NRC Question RAI 14 – Additional Response

Response

Figure 2: Illustration of the incorrect interpretation of the example uncertainties – these are uncertainties of the mean measurements and not (random) uncertainties of the single measurement.

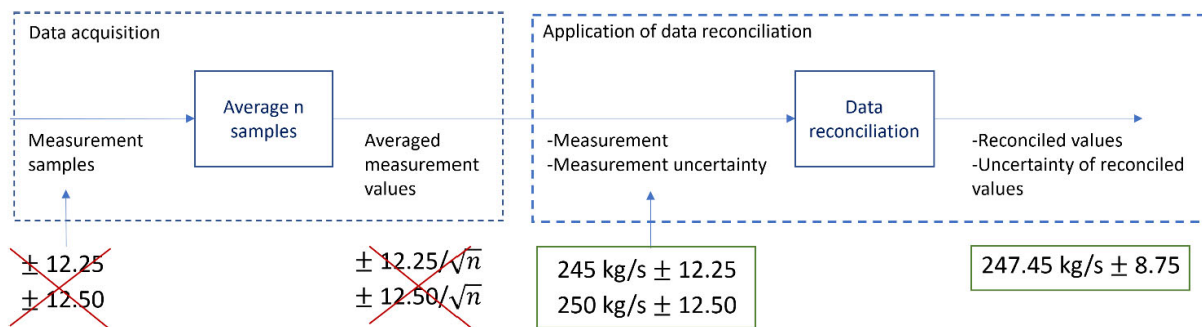
In this RAI there seems to be a misconception of the estimated measurement uncertainty as input to DVR. In the example calculation presented, the measurements are stated as $245 \text{ kg/s} \pm 12.25$ and $250 \text{ kg/s} \pm 12.50$.

In the RAI example calculation, the uncertainty intervals ± 12.25 and ± 12.50 are divided by n (after conversion to variance) before input to the DVR method, in order to convert to an uncertainty of the mean value. They are apparently interpreted as (random) uncertainty of the single measurement.

However, as mentioned above, the inputs to DVR are mean measurements and uncertainties of mean measurements, and the uncertainty intervals provided (± 12.25 and ± 12.50) already represent the uncertainties of the mean values, including any effects of sampling (see "Meaning of the measurement uncertainty as input to DVR", below). Consequently, no conversion (division by n) is required before input to DVR and no reciprocal conversion of the result (multiplication by n) is required.

Figure 2 illustrates this issue.

Figure 3: Illustration of the role of the systematic error of the measurement

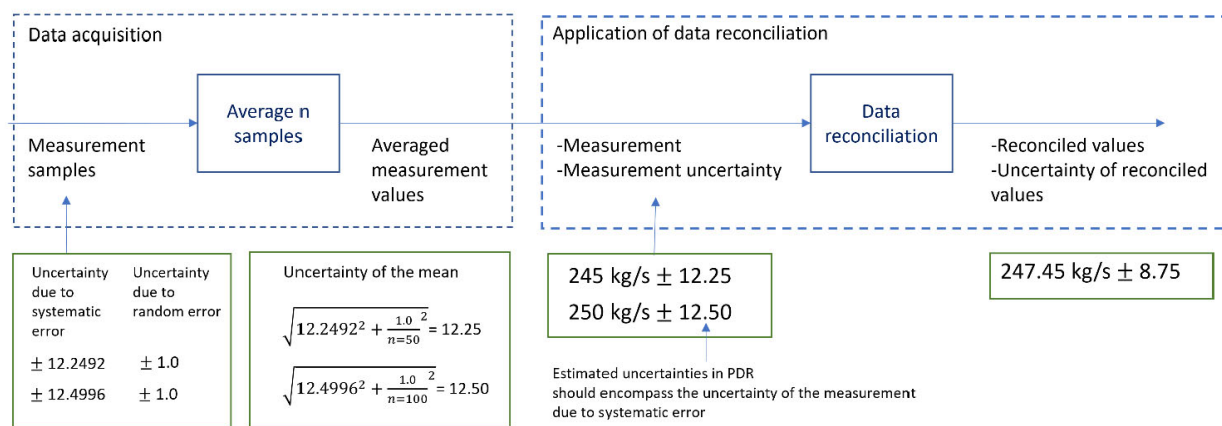
It is helpful to understand that the uncertainty of the mean measurement (the resulting uncertainty after sampling and averaging) represents the uncertainty of the single measurement due to systematic error.

Measurements contain both random and systematic errors. When calculating a mean value of n samples, the random error in the measurement vanishes with large enough sample size (the random variance is divided by n), but the systematic error of the measurement remains in the mean value (see Attachment A in the EPRI response).

Since DVR uses mean measurement values, the estimated uncertainties in DVR must include the uncertainty of the single measurement due to systematic error.

This is illustrated in Figure 3. On the left, the measurement uncertainty is given for both the systematic and random component. The random error is normally much smaller than the systematic error. Here a value of 1.0 kg/s is taken as an example for the uncertainty due to random error. The uncertainty due to systematic error is calculated to match the example. As can be seen, due its smaller size and due to averaging, the random component almost completely vanishes, and the systematic error dominates the error of the mean value. It becomes clear that for sufficiently large n , the uncertainty of the mean is the uncertainty of the measurement due to systematic error and that this is independent from n .
